**Mont-Joli Airport, Quebec
Contaminated Site (MDDEFP File: 7610-01-01-0253704)**

Remediation Plan

**Answers to the MDDEFP Emails of
April 30, 2013 and May 30, 2013, and to the
Request for Additional Information of September 3, 2013**

Revision 01

Dessin / Drawing: Figure 2.1
Localisation des secteurs d'intervention
et des limites de lots

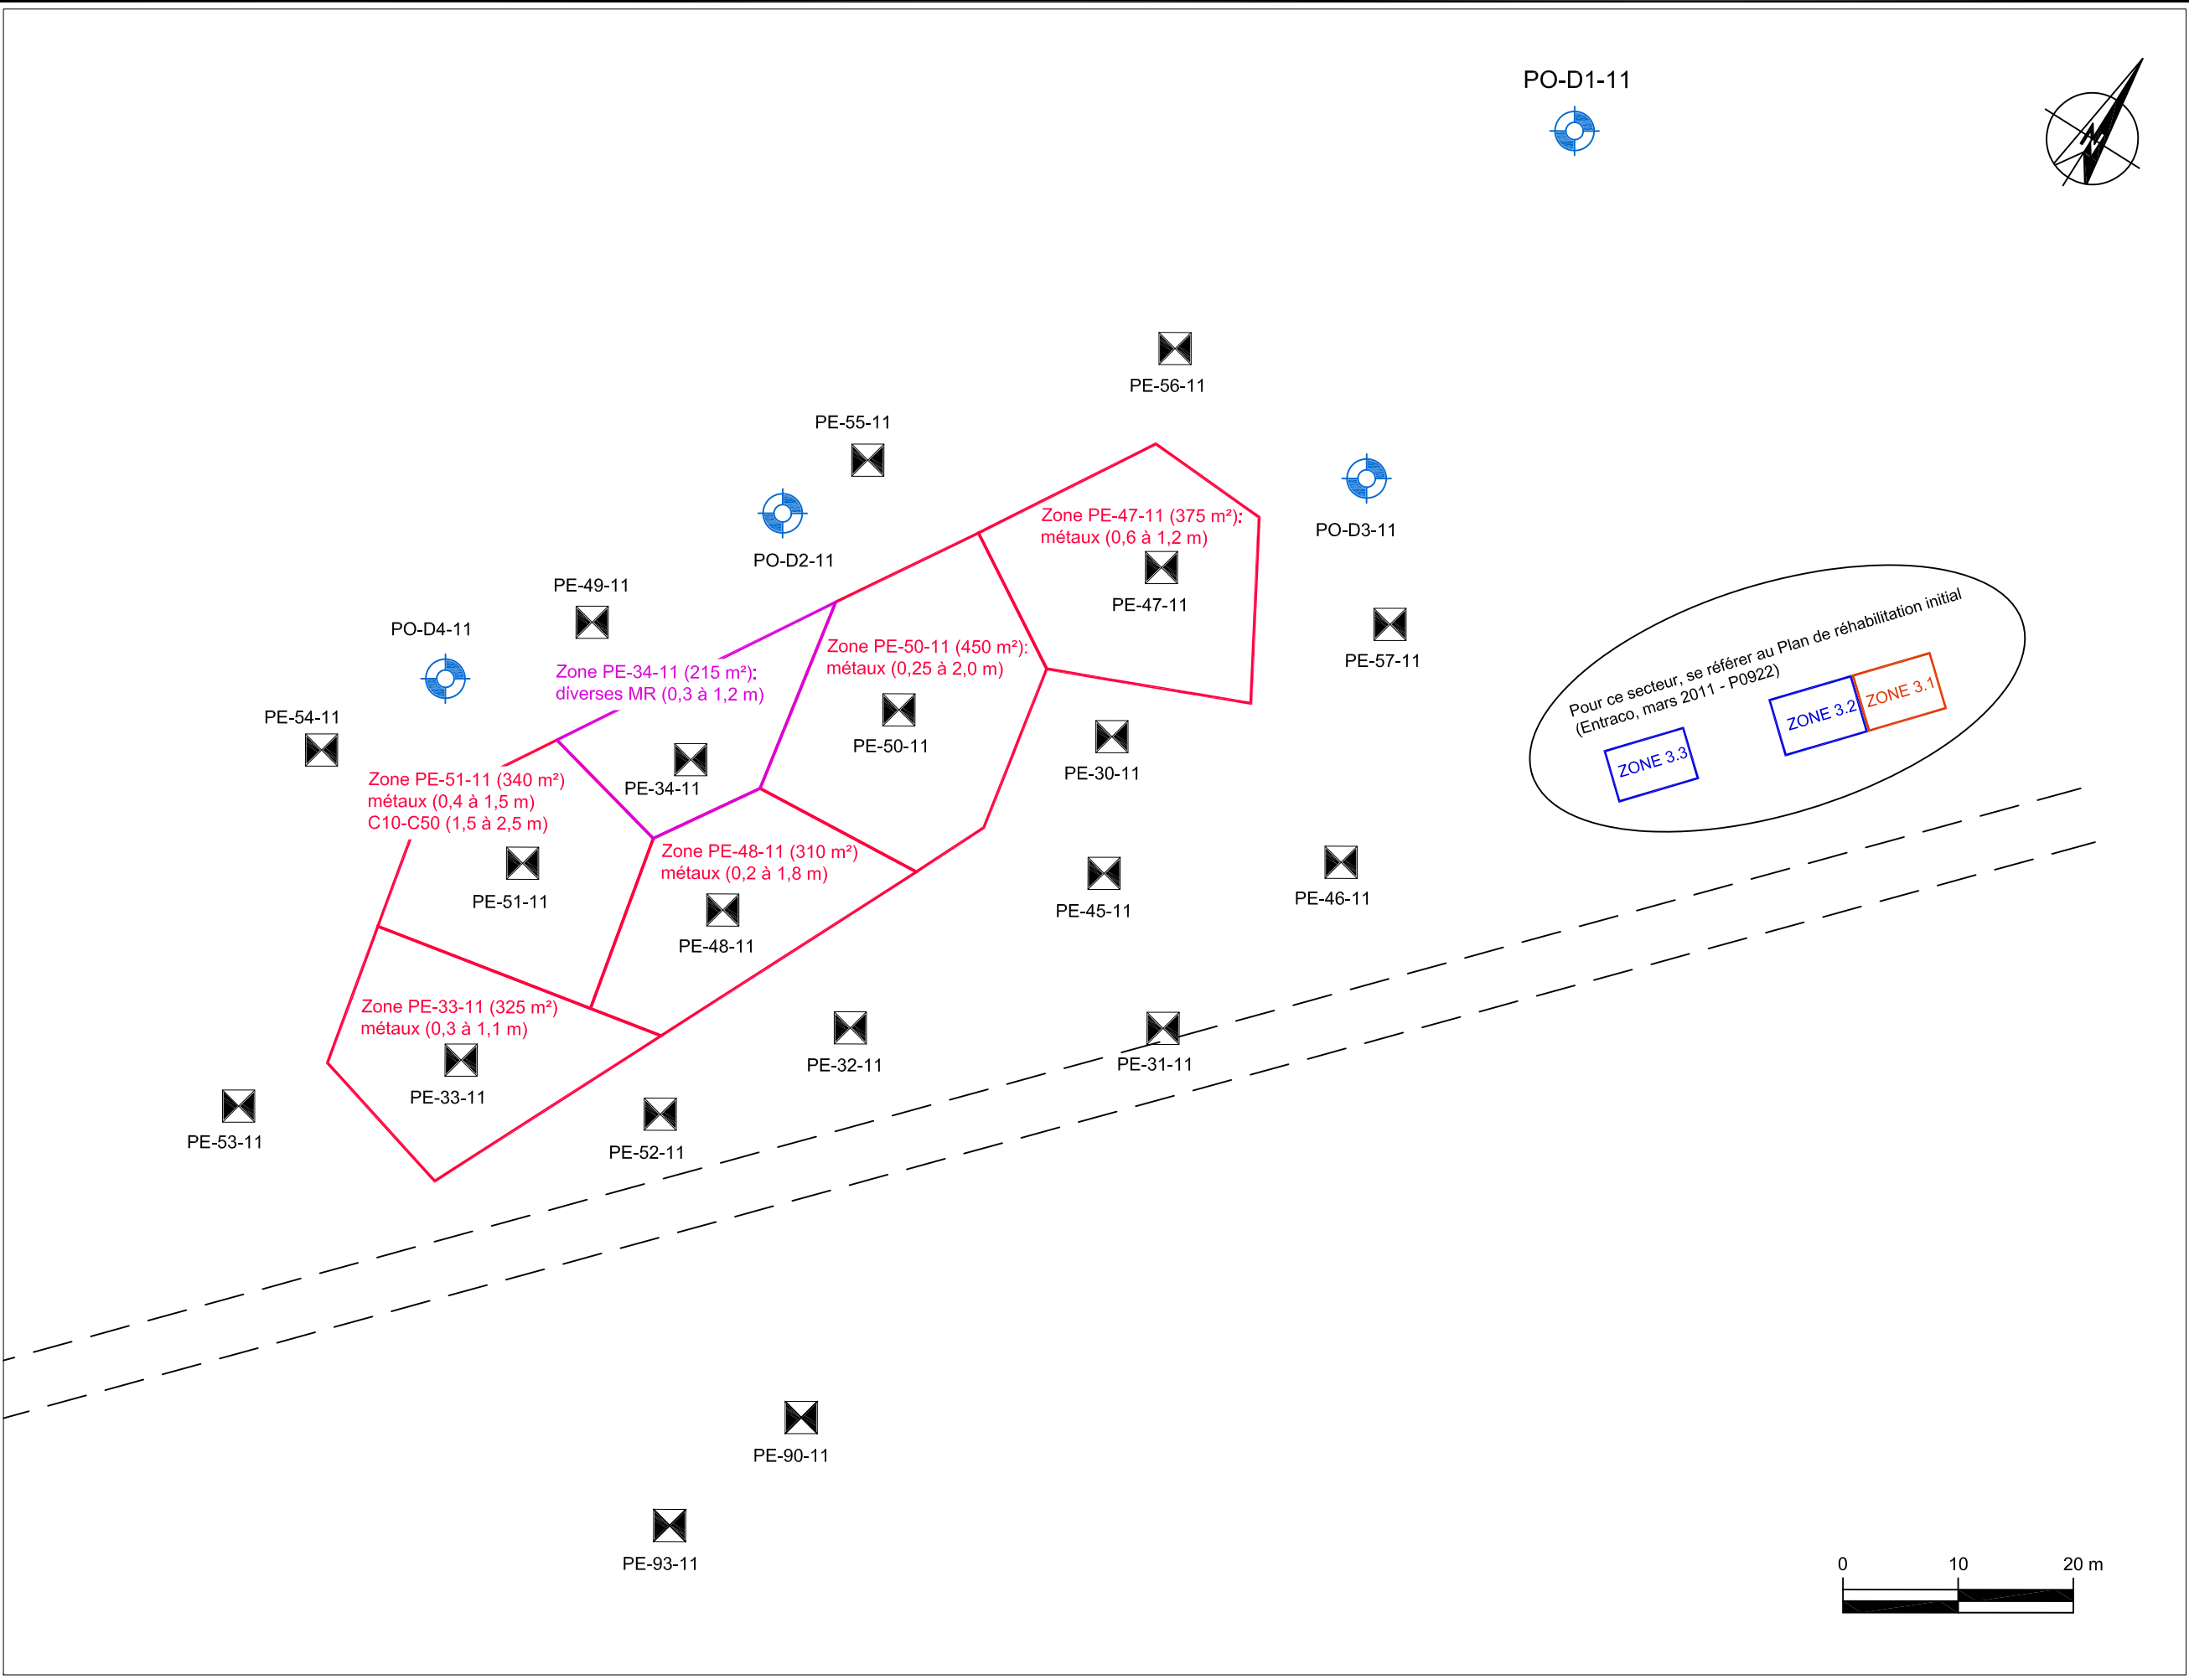
1. Remediation Plan: Provide updated plans to take into account the new divisions of the lots on the site in question (lots 4 804 508 and 4 804 509).
2. In tables 2.1, 3.2, 4.2 and 5.1 of the remediation plan, the areas and volumes of zones PE-62-11 and PE-63-11 do not match the areas and volumes established in the characterization study. To be corrected. Also, in Table 2.1, the location in the cadastral description needs to be updated.

1. The boundaries of the new lots 4 804 508 and 4 804 509 were added to the figures (see Appendix 4).
2. The surface areas and volumes presented in tables 2.1, 3.2, 4.2 and 5.1 (see Appendix 3) were amended to match those in the certified LVM characterization study. The values presented in the amendment to the Plan (Entraco, March 2012) were calculated considering the presence of concrete septic tanks. The new values are as follows:

Dessin / Drawing: Figure 2.3
Localisation des zones d'intervention -
Secteur des fosses

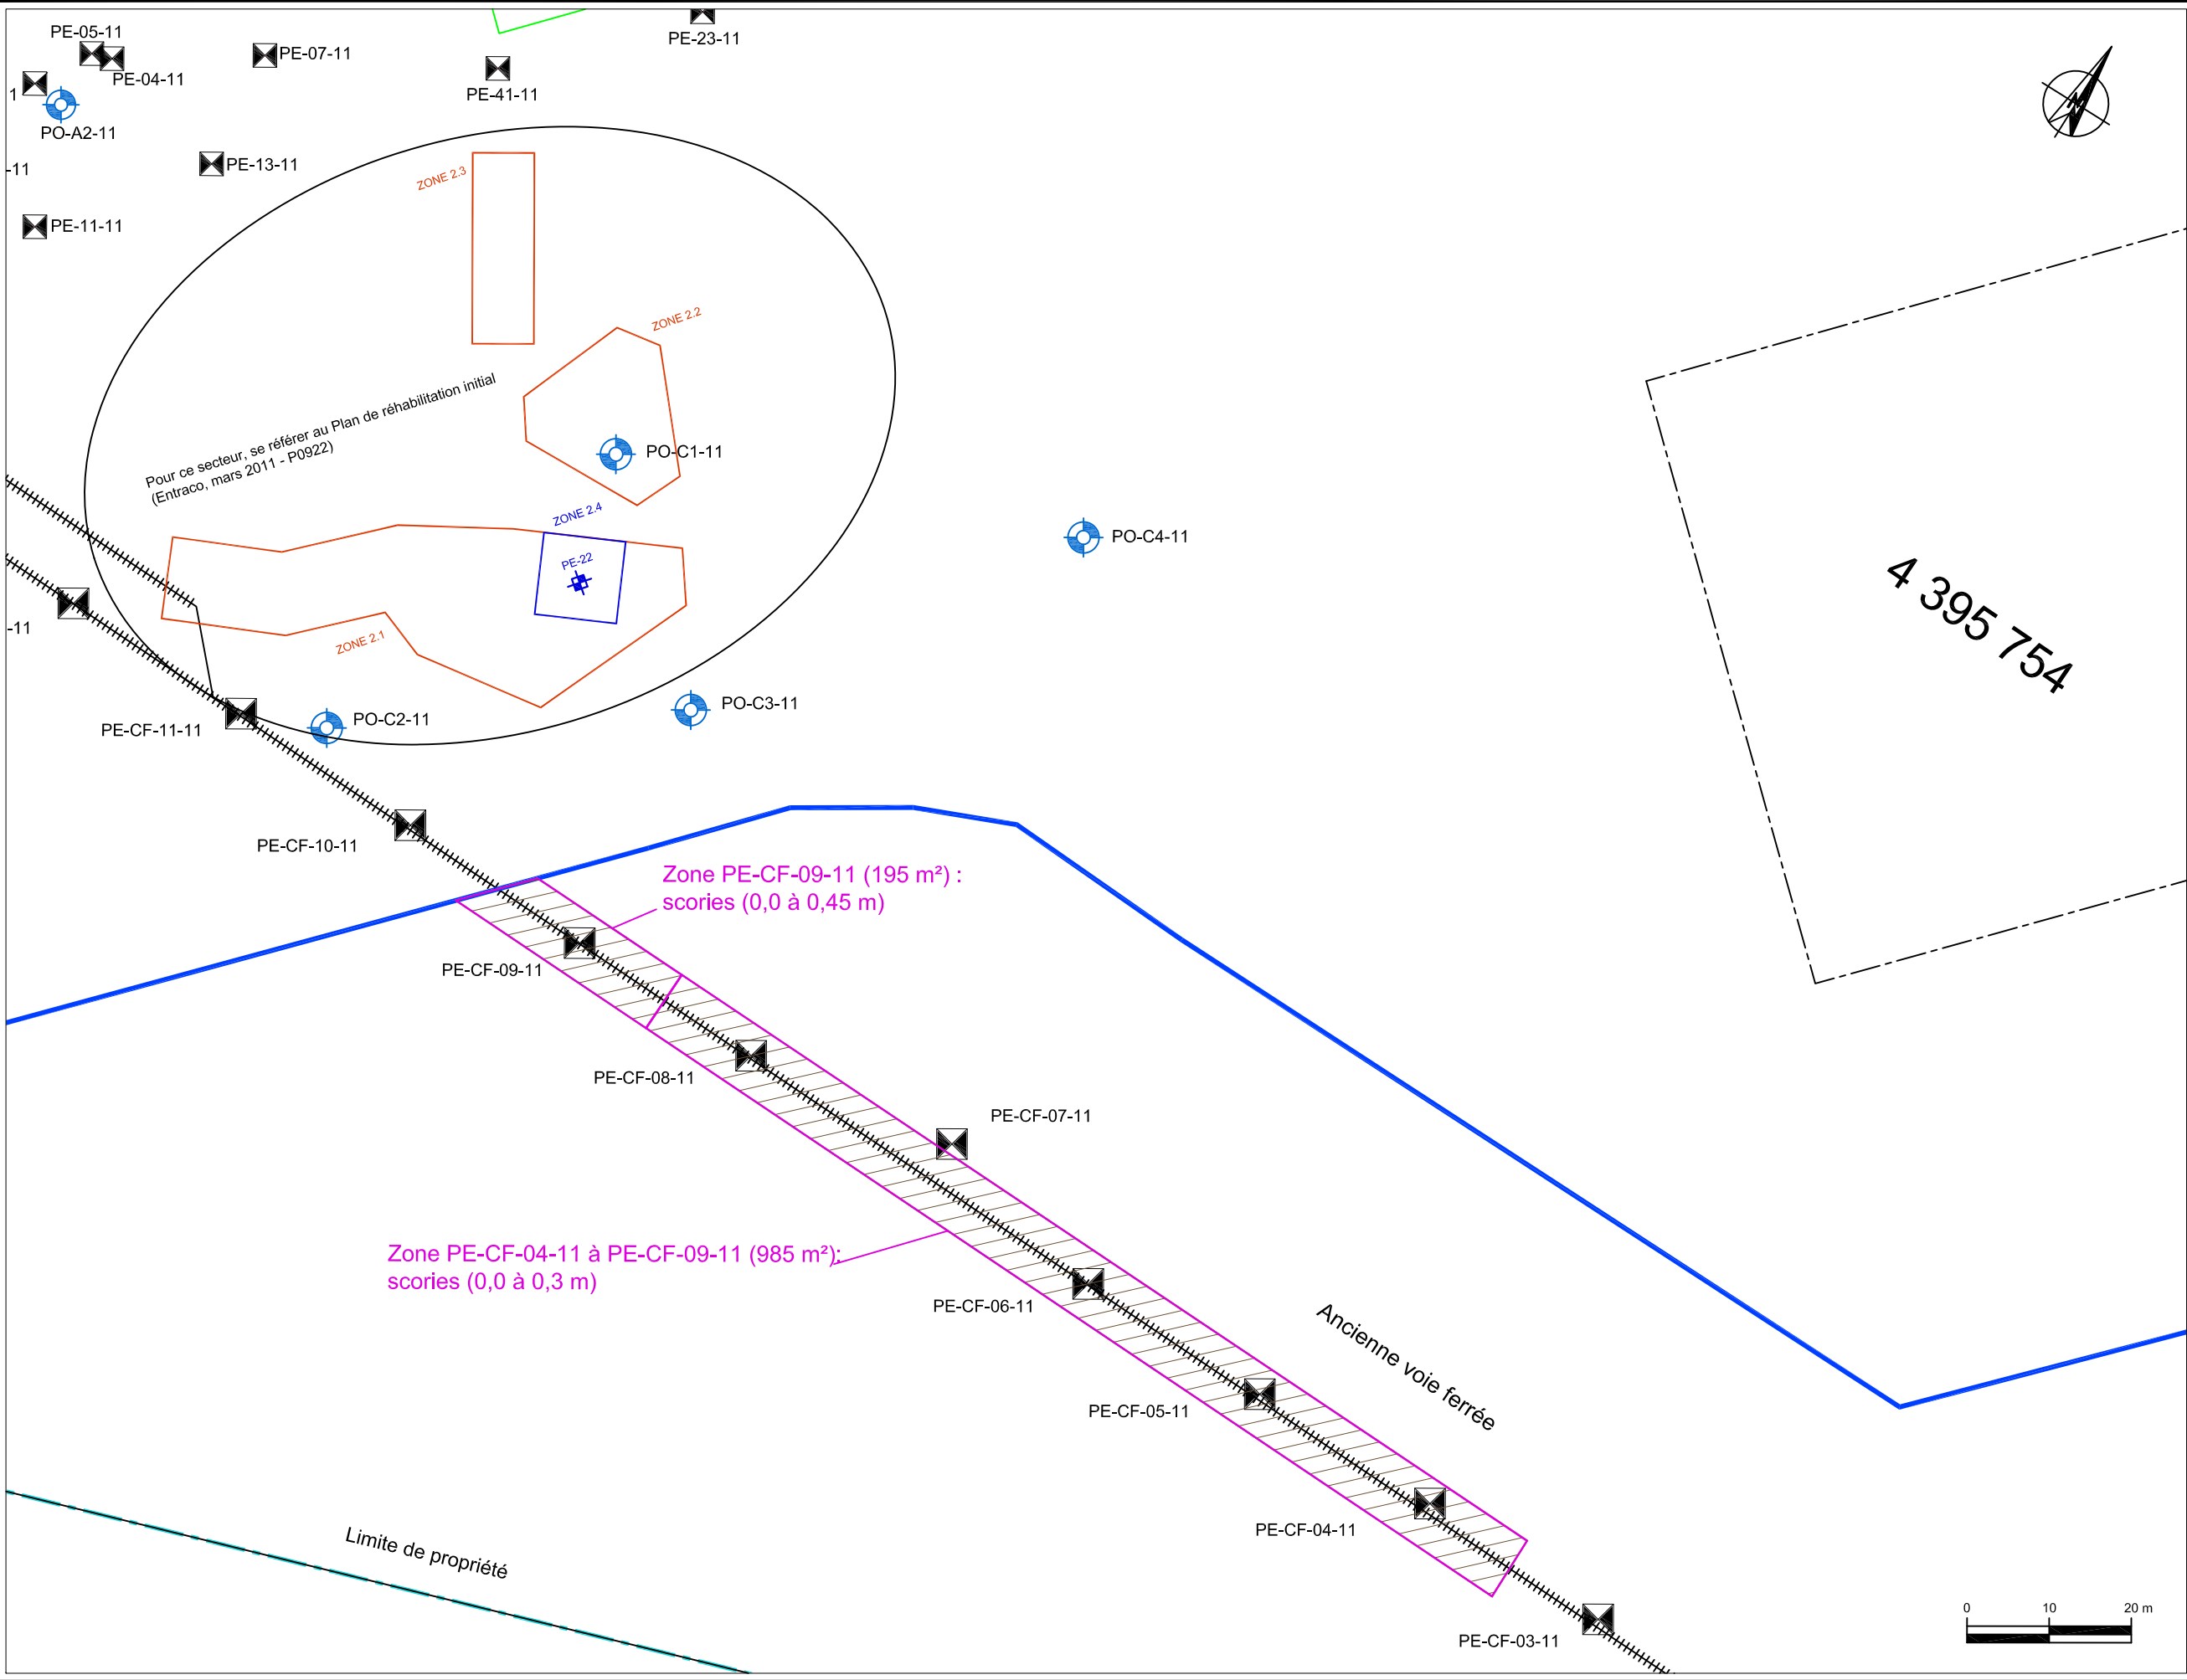
Regarding the characterization study, note that duplicate DCS-23 of sample PE-50-11-2 did in fact show C-D Mn contamination (3,500 mg/kg), and sounding PE-50-11 is therefore deemed to be C-D Mn-contaminated. Since this sounding is also Cu-, Pb- and Zn-contaminated and excavation of the contaminated soil is already provided for in the remediation plan, no further discussion on the matter is required.

However, in the characterization study, out of 29 samples analyzed for manganese, only 6 revealed B-C contamination, and only 2 revealed C-D contamination (samples PO-F1-11-CF4, at 2,700 mg/kg, and DCS-23). More specifically, in the former septic tank sector, from which sample PO-F1-11-CF4 was taken, the samples collected in similar horizons (layers) of soil in a radius of approximately 20 m do not show as high a level of contamination (often below criterion A). It is therefore questionable to conclude that the contamination of sounding PO-F1-11 is associated with natural levels, bearing in mind that according to the current guidelines, backfill soil is excluded from background levels. Therefore, in absence of a clear indication of the natural origin of the contamination in accordance with the current guidelines, **MDDEFP maintains its position on the Mn contamination of sounding PO-F1-11. Management of these contaminated soils must be included in the remediation plan, including an update of the plans submitted and the estimated volumes and surface areas of the contaminated soils.**

To take into account the manganese contamination present (C-D range) in sample PO-F1-11-CF4 (between 2.28 m and 3.05 m), an 88-m² contaminated zone with a total volume of 79.2 m³ has been added (see Table 3.1 and Figure 2.3 in Appendix 4). This zone, PO-F1-11, will be remediated according to the directives in section 4.1.2 of the amendment to the Plan (Entraco, March 2012) and tables 4.1, 4.2 and 5.1 (see Appendix 3).
